SUBJECT: PRESENTATION MATERIALS FROM THE APRIL 27, 1995 MEETING ON
AP600 IN-VESSEL RETENTION SEVERE ACCIDENT TOPICS

AP600 In-Vessel Retention of Molten Core Debris

AP600 Cavity Flooding Performance

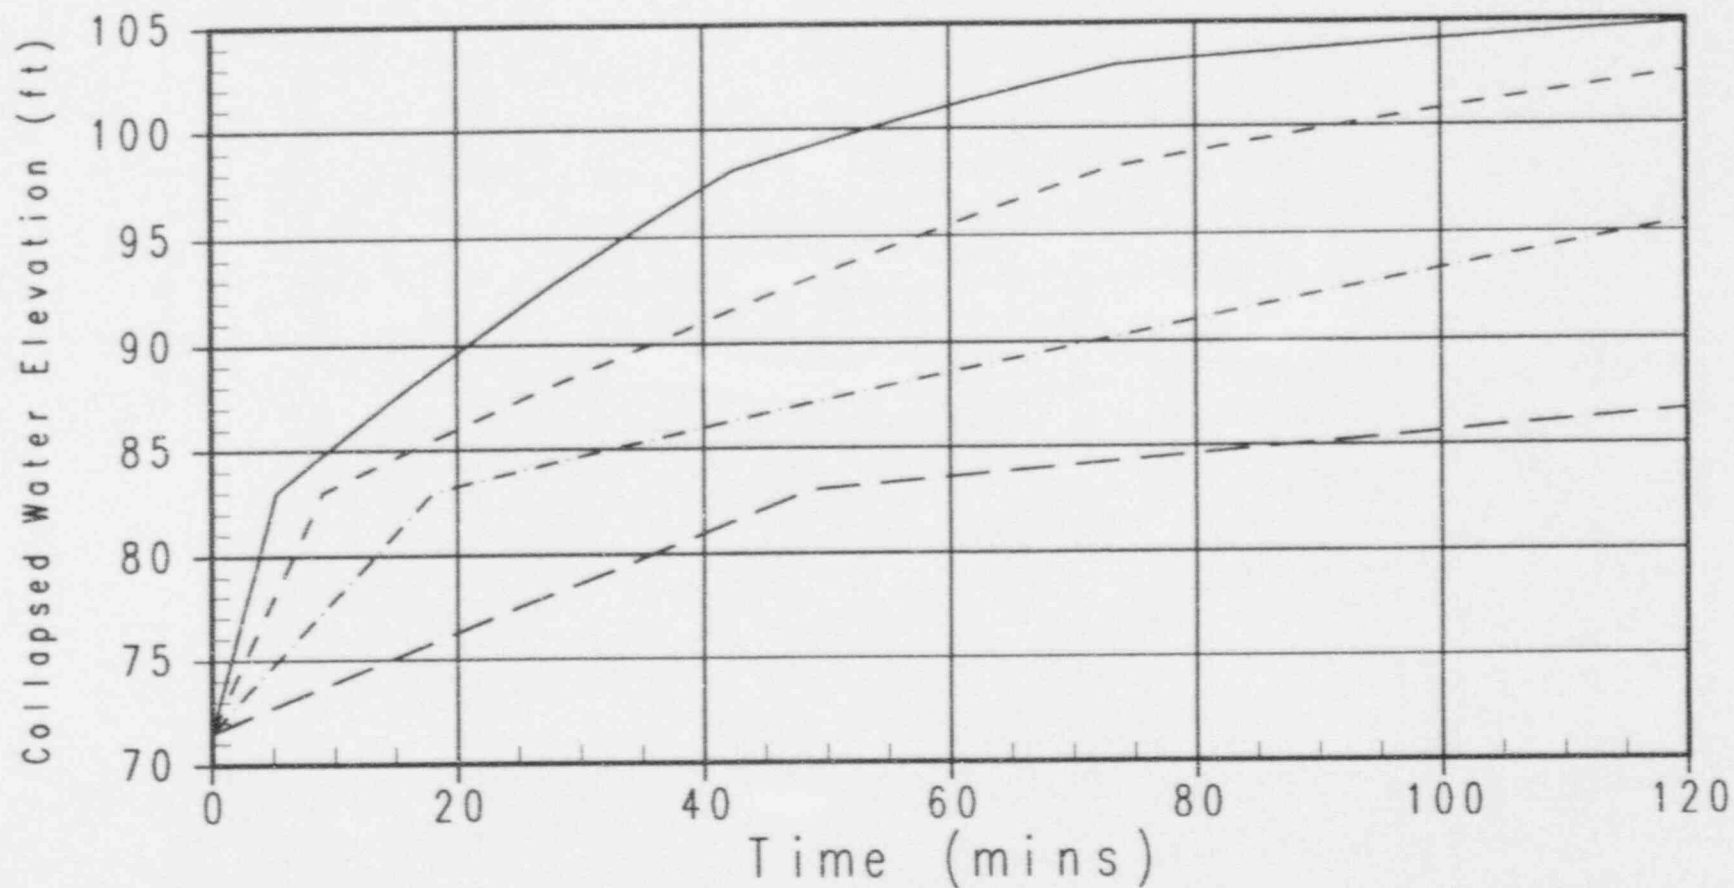
480.85 Cavity Flooding Valve Sizing Basis and Water Level Success Criteria

- Cavity Flooding System consists of two 6" diameter lines.
- Sizing based on NRHR pump suction requirements with both pumps running unthrottled
- Minimum water level is 2m above the top of the hemisphere (elev. 90') at the time that the bulk debris temperature exceeds the melting temperature of the wall (based on review of MAAP4 results)

Best Estimate Containment Flooding with One Line
1 CMT and 2 Accums Initial Water Volume = 5400 ft³

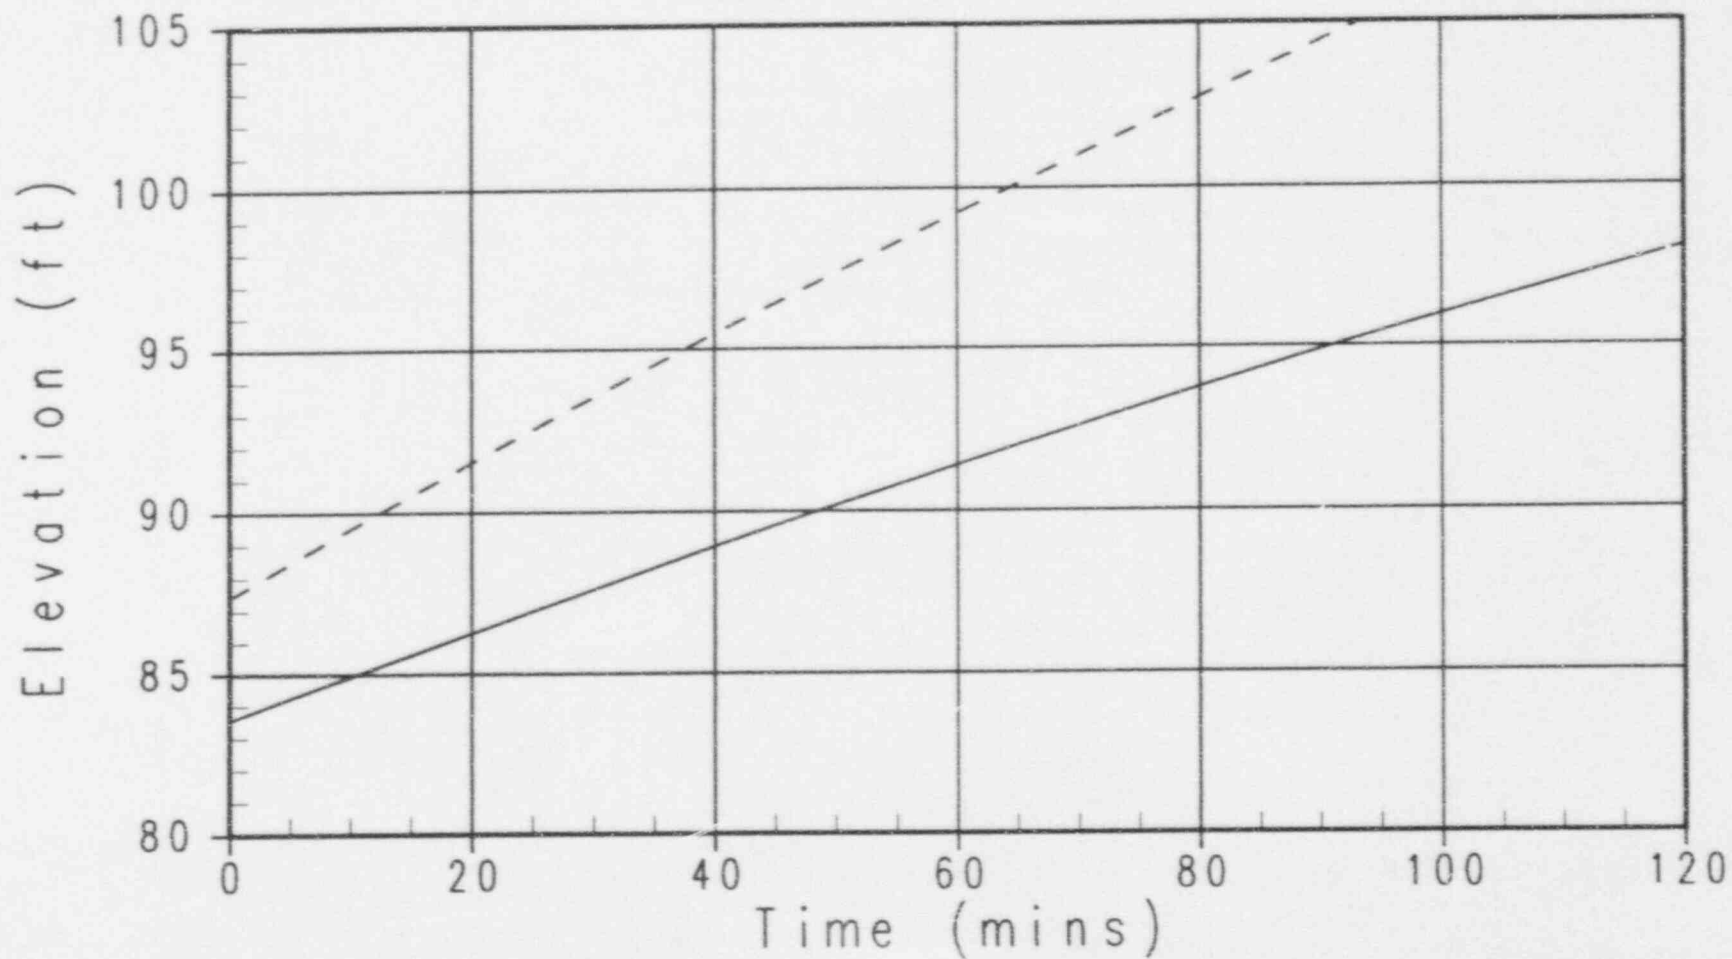
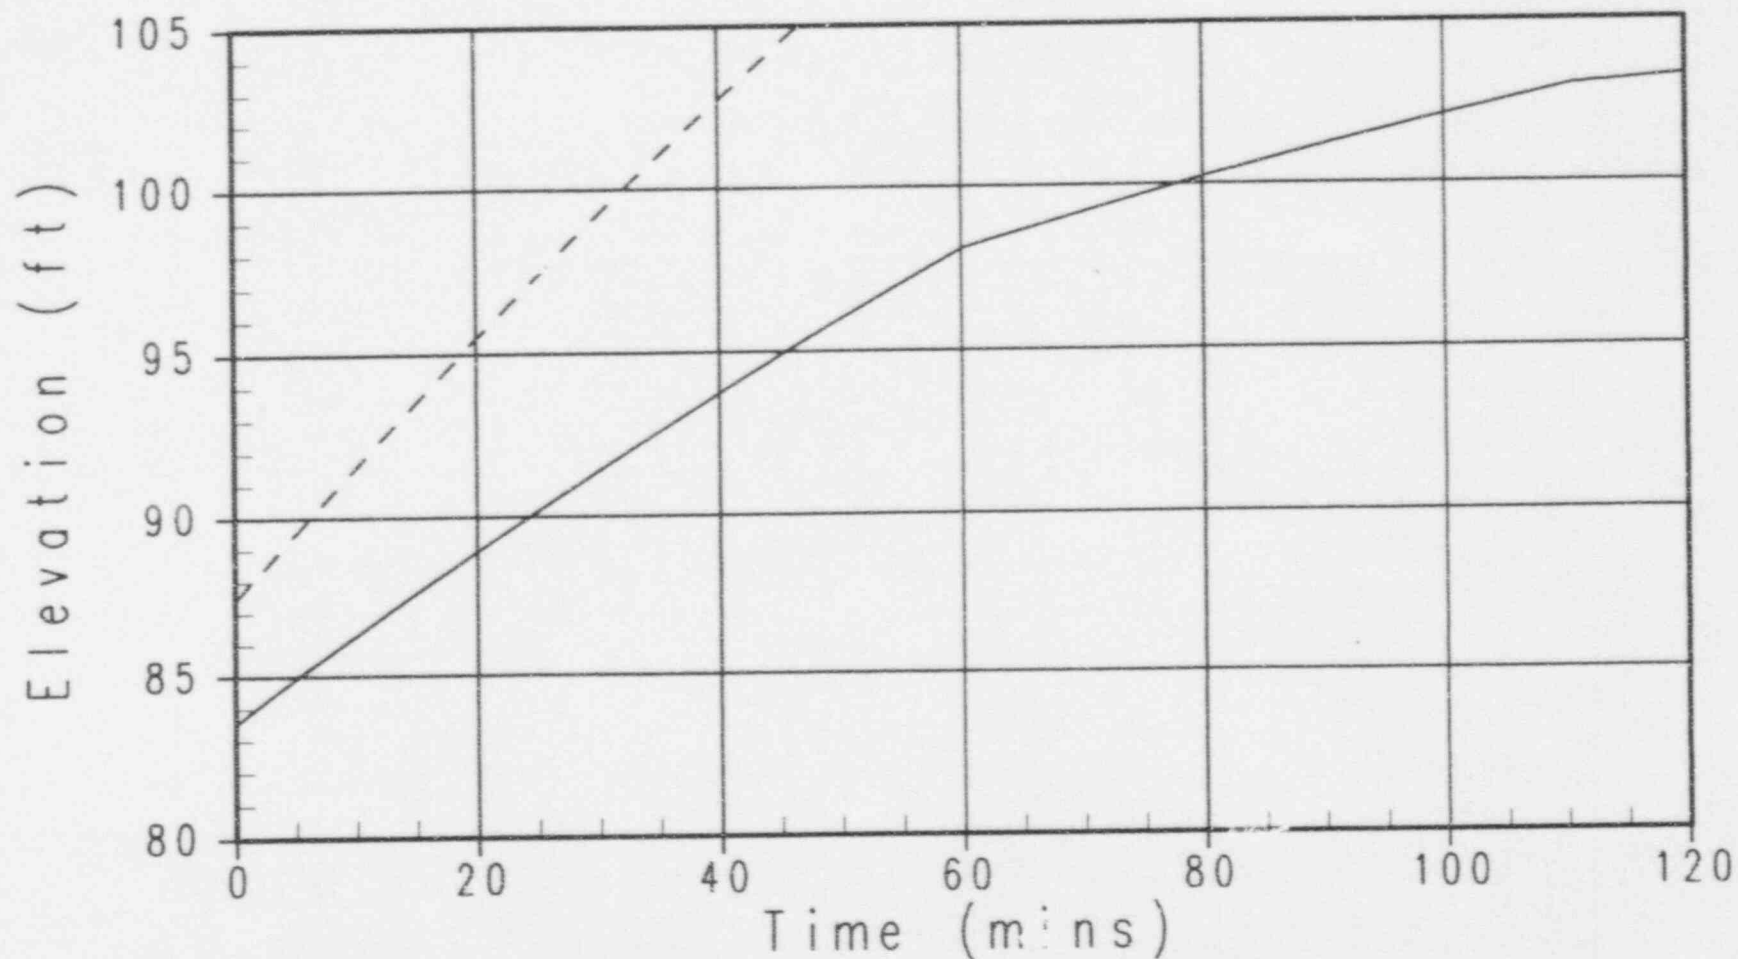
480.86 Delayed Cavity Flooding

- Best-estimate is that cavity is flooded up to the top of the hemisphere prior to cavity flooding action
- Less than 20 minutes to flood up to the top of the hemisphere (max debris pool level) considering one 6" line and no pre-flooding
- less than 100% of debris relocation within 1 hour
- water in lower head cools debris heat transfer to vessel wall, then debris has to heat up again
- No delay is considered in current analysis
